DA 22/11272
**Alpine Coaster and Associated
Works**

Response to Additional Information Request

This document has been prepared in response to the ***Request for Additional Information, DA 22/11272 – Alpine Coaster, 2 Friday Drive, Thredbo (Lot 876 DP 1243112)*** issued by the Department of Planning and Environment (DPE) on 4 November 2022.

Figure 2: Example of trestle footing

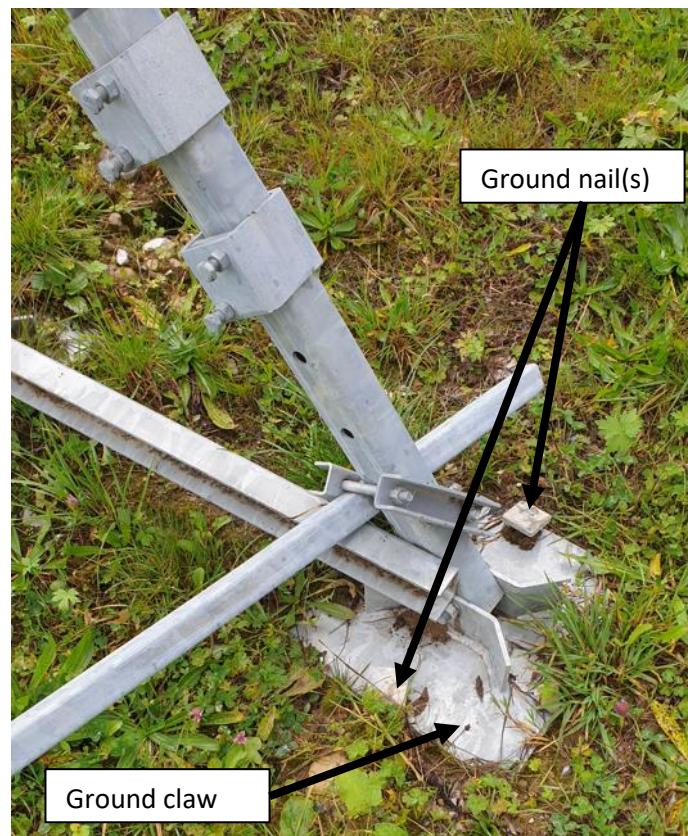
Ground stakes and support wires, including (but not limited to) how many and where, particulars of how far out they extend, how they will be clearly identified for all recreational users in the locality (also refer to safety considerations requested elsewhere).

- Those that require a concrete footing and tubular steel tower. The location of these are shown in Error! Reference source not found.).
- The trestle type that require only ground nails (stakes) to secure their footing plate (claw) without the need for a concrete footing. These vary in height according to the ground profile and would be installed at 3 m intervals along the majority of the uphill and downhill track wherever there are no tubular type towers. On the downhill track there will be approximately 270 trestle type supports with another approx. 90 on the uphill track making a total of 360 such supports. Trestle supports on curves require four ground nails per support, those that support straight sections of track require only two per support. Typical specifications are provided in **Appendix D**. Ground nails (stakes) do not require identification as they finish flush with the footing plate, refer **Figure 2**.

Figure 10: Directional / Safety Signage within Valley Terminal Precinct

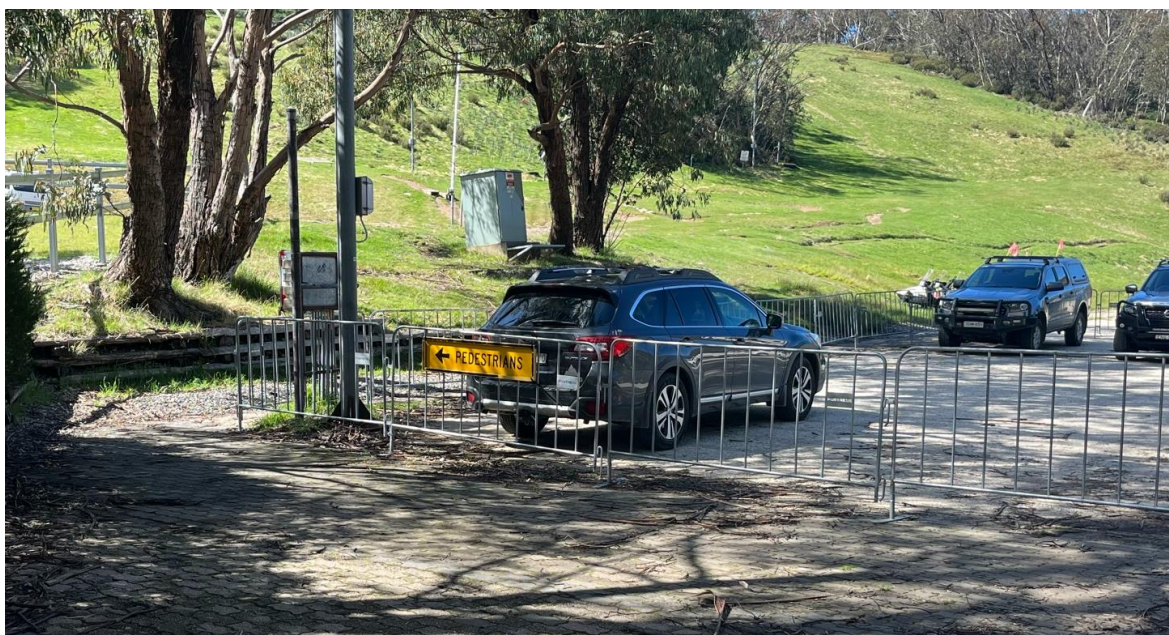
Separation of vehicles and pedestrian pathways for staff

The separation of vehicles and pedestrian pathways within the Valley Terminal precinct (including the disused tennis courts / staff carpark) is currently managed through fencing and directional signage (refer **Figure 10** and **Figure 11** for example). KT will continue to manage pedestrian and vehicle access with this approach. The replacement of crowd control type fencing (**Figure 11**) with new timber fencing around the existing operational staff carpark will also improve the aesthetics of the locality.
